Wisconsin Electric POWER COMPANY
 231 W. MICHIGAN, P.O. BOX 2046, MILWAUKEE, WI 53201

DOCKET NOS. 50-266 AND 50-301
ADDITIONAL INFORMATION APPENDIX R EXEMPTION REQUEST
POINT BEACH NUCLEAR PLANT, UNITS 1 AND 2

ENCLOSURE 1

POINT BEACH NUCLEAR PLANT
REACTOR COOLANT PUMP LUBE OIL COLLECTION SYSTEM

FIGURE 1

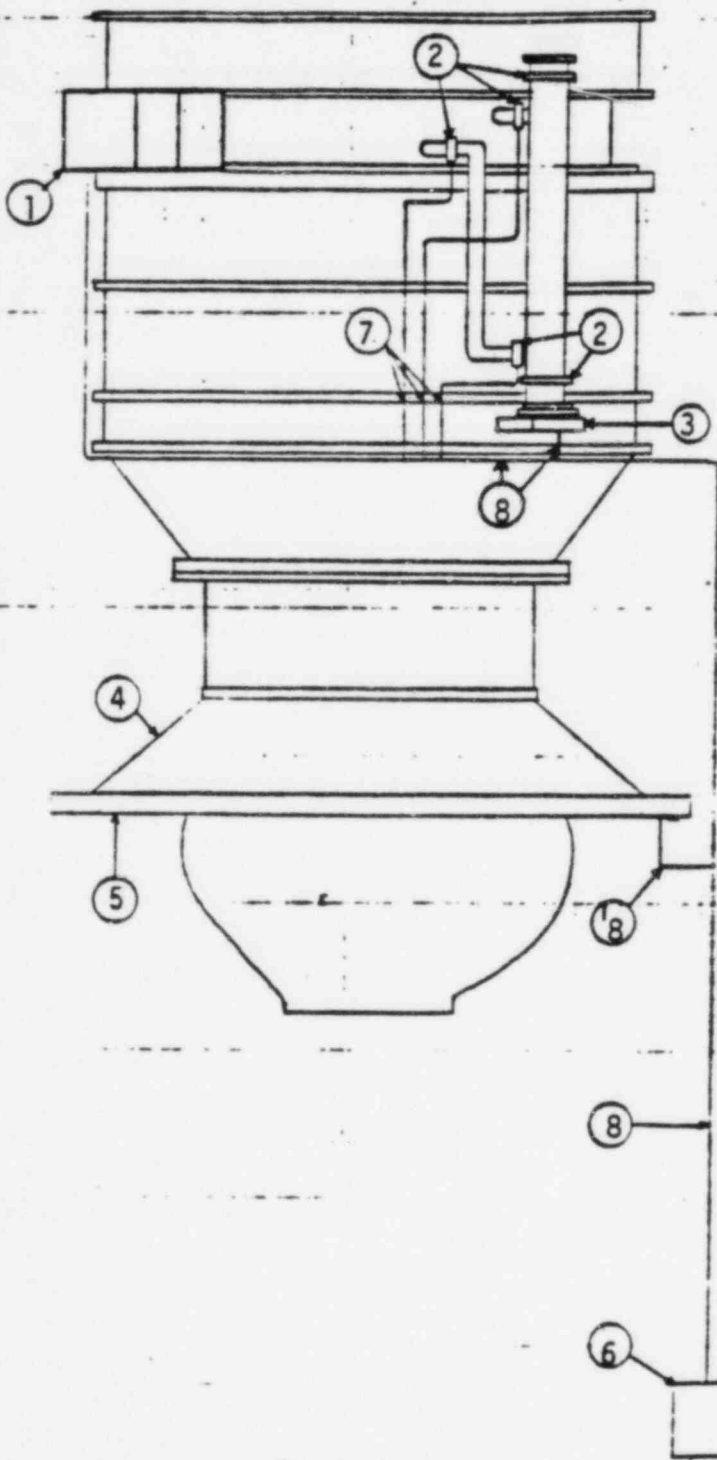
Mr. Stang requested that we describe further the oil collection system for the reactor coolant pump motor and compare the Point Beach design with other systems. The general arrangement of the Point Beach Nuclear Plant reactor coolant pump lube oil collection system was provided in Enclosure 1 to our January 29, 1982 letter. The system is designed, engineered, and installed to satisfy the seismic requirements of Section III.0 of Appendix R. The oil lift pump and piping enclosure and flange covers on the lube oil cooler and piping provide for protection and collection from all pressurized oil leakage sites. The oil collection tank is suitably protected to prevent fire flashback.

Enclosure 1 states that the system will meet the intent of Section III.O of Appendix R. Our use of the word "intent" is based on the following specific wording of Section III.C:

In an effort to satisfy the above specific wording, other system designs provide individual devices for oil collection from unpressurized leakage sites. The Point Beach system for oil collection from unpressurized leakage sites, as described in paragraph 1 of Enclosure 1 to the January 29 letter, utilizes the pump shaft housing as a collection sump and an oil deflector cone to keep unpressurized oil leakage from contacting the hot reactor coolant pump body or piping. The technical basis for Section III.O expresses the concern that "oil leaking from some portion of the lube oil system may come in contact with surfaces that are hot enough to ignite the oil". The Point Beach oil collection system prevents this from occurring, and thereby satisfies the technical basis of Section III.O. Therefore, we consider the Point Beach oil collection system to meet the "intent" of the above-listed specific wording by satisfying the requirements of the Section III.O technical basis.

The major potential for oil leakage occurs during normal operation from unpressurized sites. This leakage can run down the shaft, exit the shaft housing, and ignite upon contact with the hot reactor coolant pump body. At Point Beach Nuclear Plant, we have closed up openings in the pump shaft housing so that the housing provides an approximate 20-gallon capacity oil sump. The housing has been fitted with an overflow pipe so that additional oil leakage will overflow onto the existing oil deflector cone. The existing deflector cone will prevent oil from coming in contact with the hot reactor coolant pump body. A leak-off tray will be added to the deflector cone with drain piping to a collecting tank. Spilled oil will thereby be diverted and collected away from its potential ignition source. We believe that this system will provide suitable oil collection from unpressurized leakage sites.

It is conceivable that some quantity of oil could be sprayed out of a small leak in the high pressure system during the less than three minutes of lift pump operation. The quantity of oil spilled would have to be small to avoid low-level alarm annunciation. However, we recognize that this could be a fire hazard. Therefore, an enclosure will be provided around the oil lift pump and piping, oil cooler oil piping will be equipped with flange covers, and an oil cooler drip pan will be provided to contain oil leakage from high pressure sources.

The general arrangement of the reactor coolant pump lube oil collection system is shown on Figure 1. The protective components of this system will collect potential oil leakage from pressurized and unpressurized sources and drain it away from hot potential ignition sources. The system will meet the intent of Section III.O of Appendix R.
